This firmware is used on the following Keithley Instruments product models:

- Model 2460 High-Current Interactive SourceMeter® Instrument
- 2460-NFP
- 2460-RACK
- 2460-NFP-RACK

VERSION 1.7.7 RELEASE

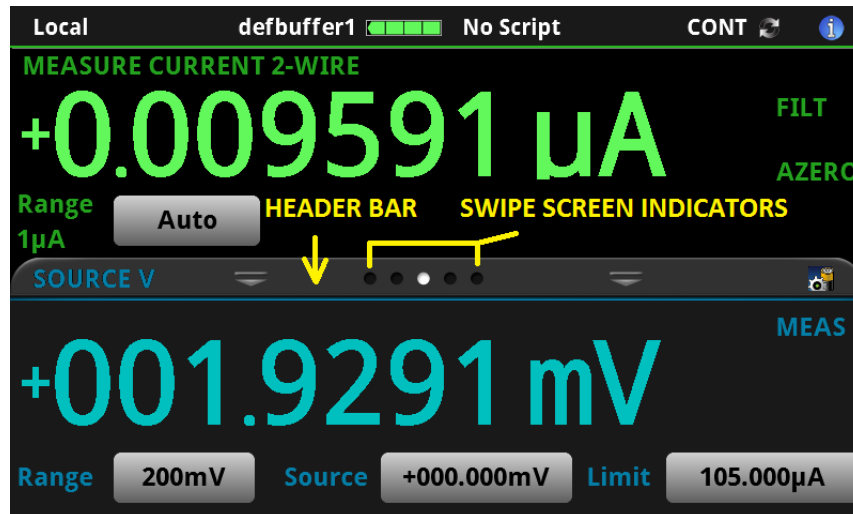
A number of improvements have been made to the overall Graphical User Interface as follows:

1. Screen Colors: All screen colors have been modified for better contrast and easier readability.
2. Pinch-to-Zoom Performance: Throughout the user interface, the “Pinch-to-zoom” touch screen motion has been improved and is more responsive.
3. Improve Swiping:
 - a. The swipe user interface gesturing has been dramatically improved and is more responsive.
 - b. Added Vertical Swiping in various screens in the GUI.
 - c. Horizontal swiping has been made more smooth and is consistent with Vertical Swiping.
 - d. “Fling” swiping has been implemented where faster swiping actions result in rapid scrolling followed by decay based on the velocity of the “fling.”
 - e. Swipe Down on the Home screen will display larger readings.

4. Tabs and Buttons: Throughout the user interface multiple data display options have been made available through tabs (header bars) with swipe screen indicators to show how many different display options are available and which display tab is active.

5. Graphing:
- New Auto Scale Options (X-Axis) → Track Latest, Track Group
 - New Auto Scale Options (Y-Axis) → y-swim lanes, y-shared, y-per trace
 - Multi-Trace Line Plots
 - Multi-Trace Scatter Plots
 - Various refresh and performance improvements
6. Histogram:
- New Auto-Scale, Auto-Bin, and Fit
 - SmartScale choose best scaling option
 - Various refresh and performance improvements
7. TTI Synchronization: All Touch, Test, Invent™ Keithley Models including the 2450, 2460, and 7510 have been carefully updated so that they are all consistent in look, feel, and general navigation.

8. Updated Reading Table: Added new reading table features and a new Reading Preview Graph. Please see the Reference Manual for further details.
